DATE: March 18, 2009

## Addenda No. 2

SUBJECT: OR126: Horseshoe Creek - Siuslaw River Section  
Florence - Eugene Highway  
Lane County  
Grading, Drainage, Structures, Paving, Signing, & Illumination Project  
(Bids to be opened and read March 26, 2009)

STRUCTURE NO. See Above  
 BDS  
 DWG. NO. 80928  
 SHEET NO. GC-7

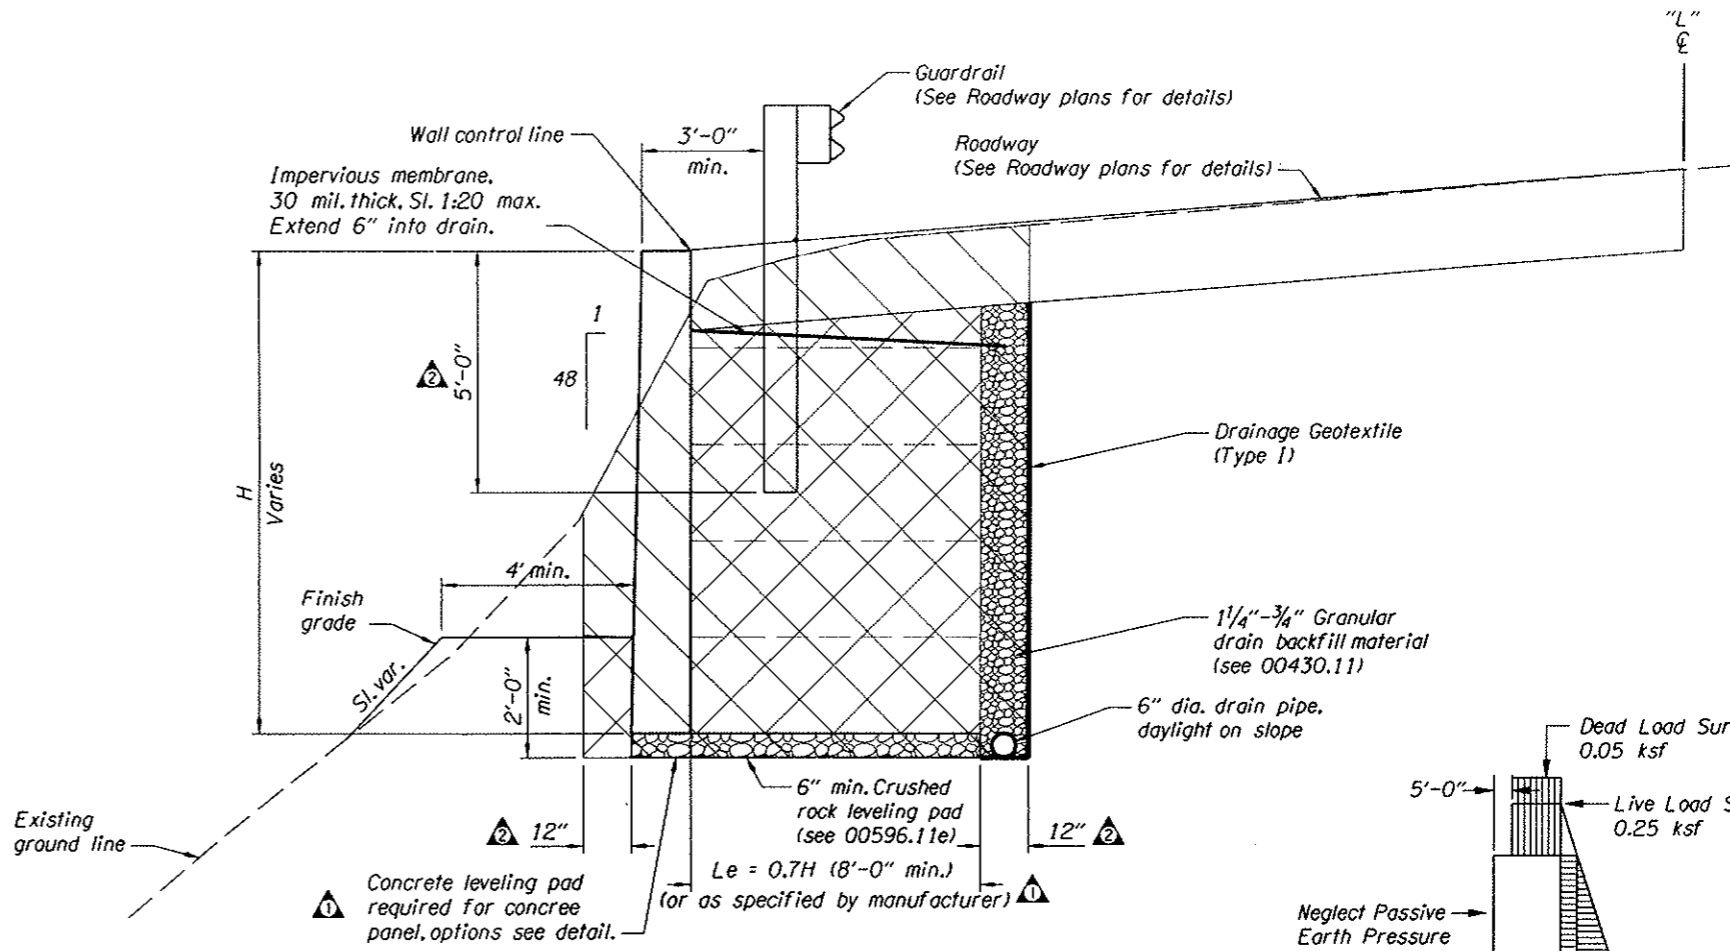
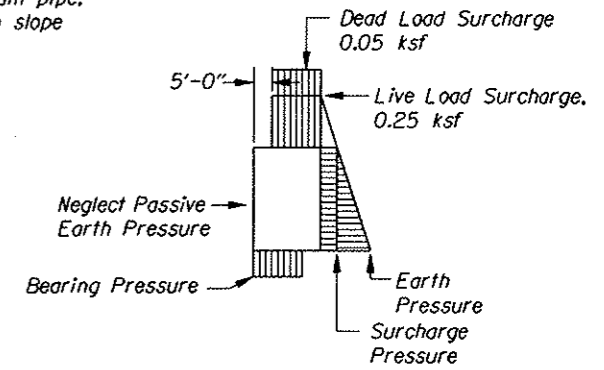
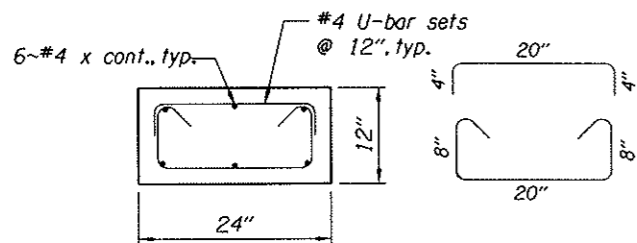
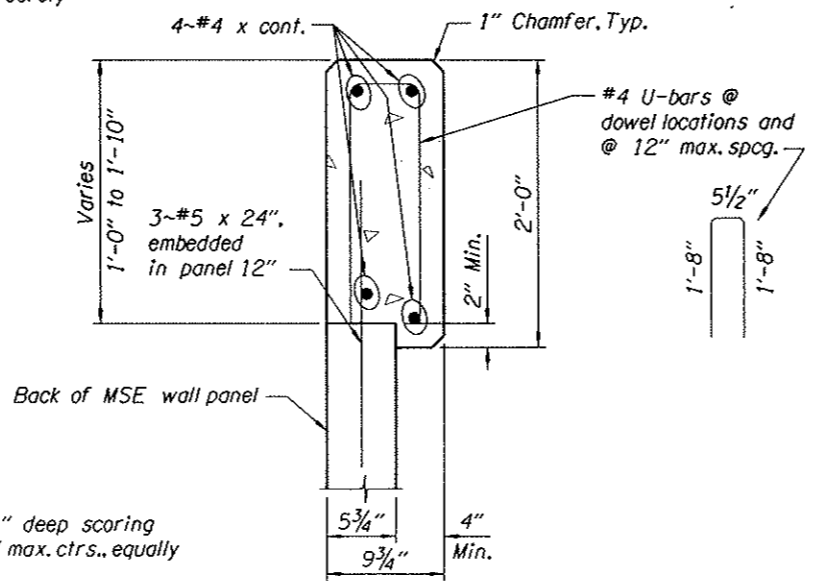
- $\Delta$  3-9-09 Changed Dimensions, Friction Angle & Added Detail
- $\Delta$  3-17-09 Changed Dimensions

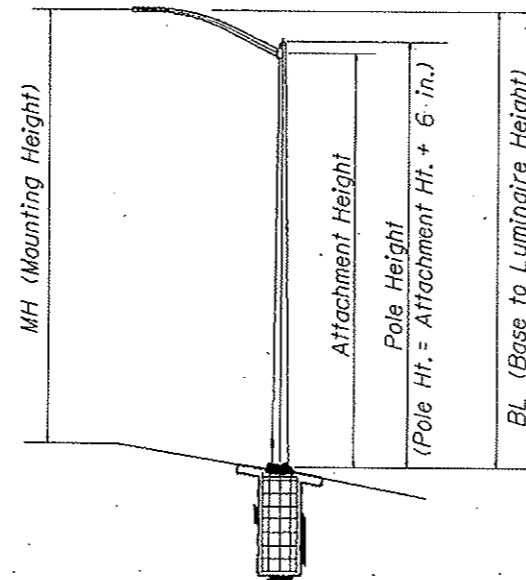
REVISIONS
 Revised 03-18-2009 Changed pole height
